SILO PROJECT INDEPENDENT REVIEW TEAM DOCUMENTATION - OPERABLE UNIT 4 VITRIFICATION PILOT PLANT FAILURE MODES EVALUATION ANALYSIS

OPERABLE UNIT 4
VITRIFICATION PILOT PLANT
FAILURE MODES EVALUATION ANALYSIS

August 19, 1996

Figure A-26 IGN

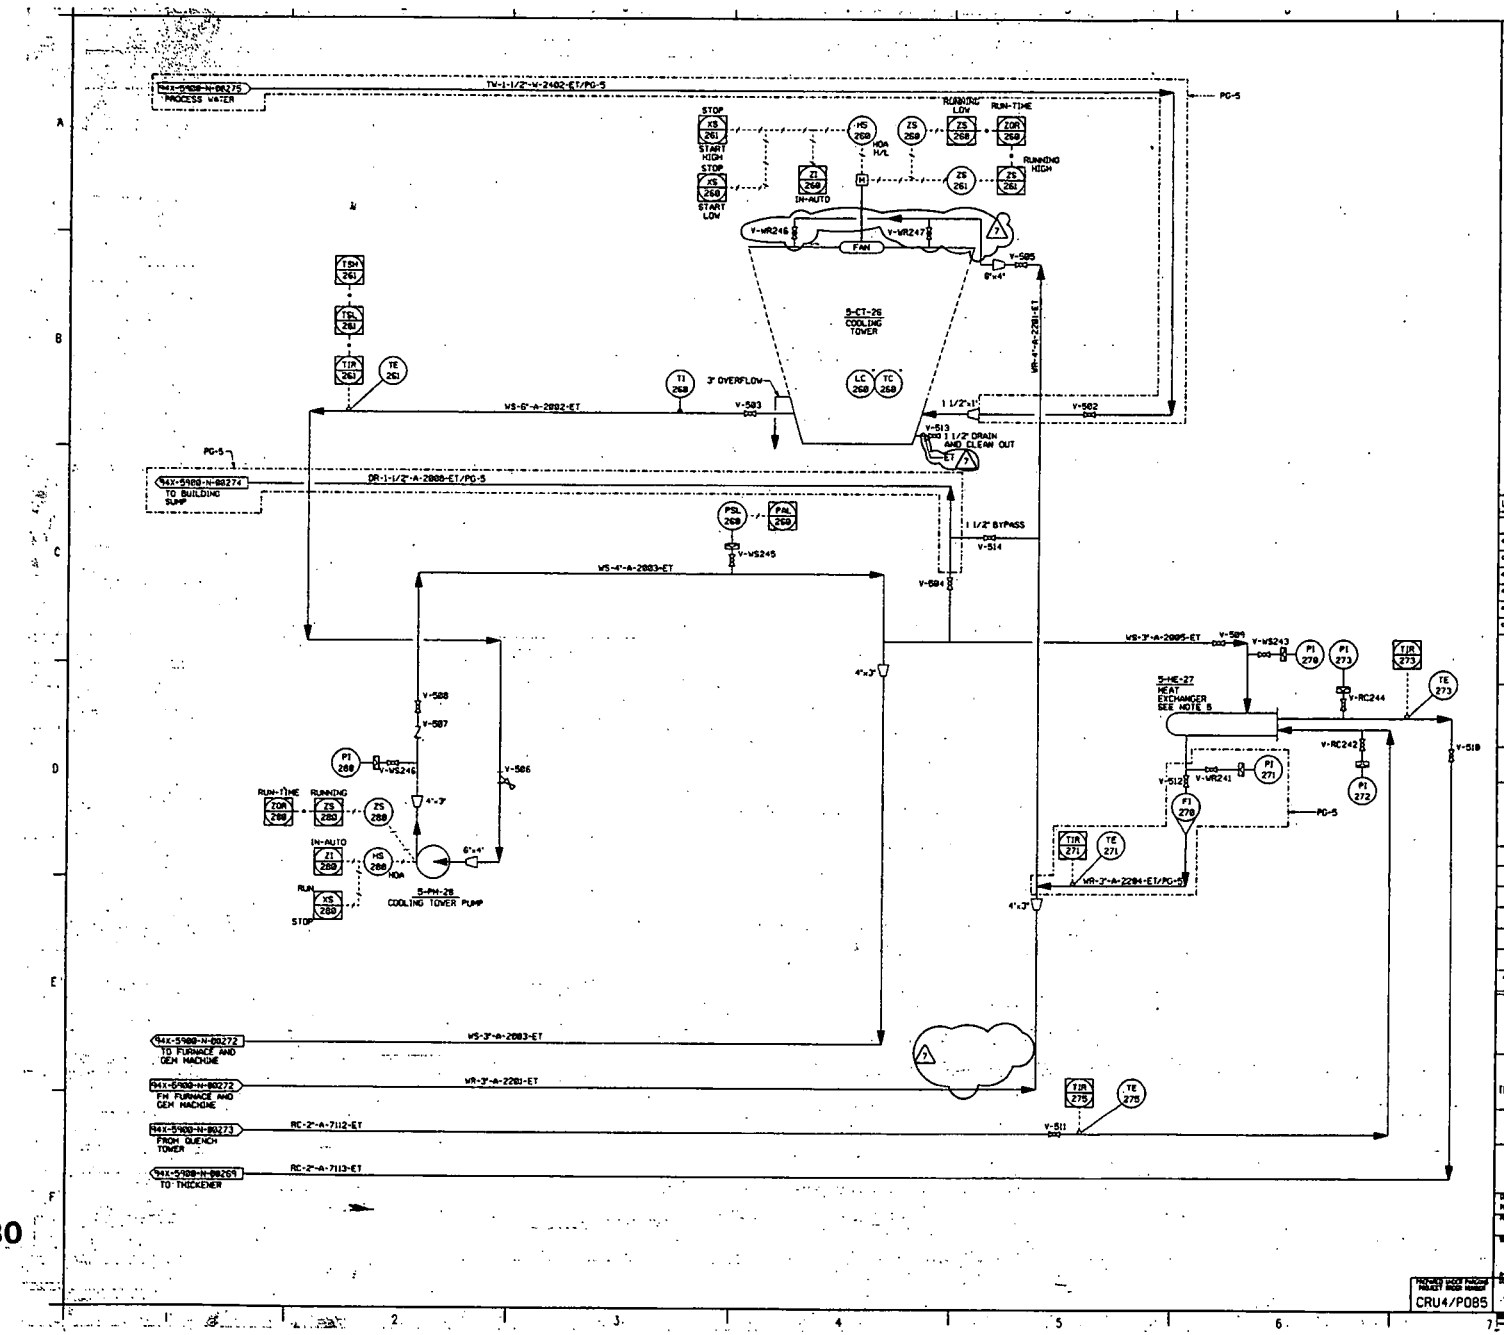
rejection for the Quench Tower liquid, and eventually cause a plant outage condition. It is recommended for consideration that a redundant cooling tower pump be added to this system to provide backup capability.

Cooling Tower Fan, 5-CT-26: The cooling tower fan removes heat from the Quench Tower liquid. Failure of the fan to provide this function will result in loss of forced air flow. Maintenance procedures may mitigate a plant outage condition (e.g., replace fan/motor) since natural draft in the tower will permit a cooling period until temperature limits are exceeded. It is recommended that the fan be placed on standby power to support the off-gas system (on standby power).
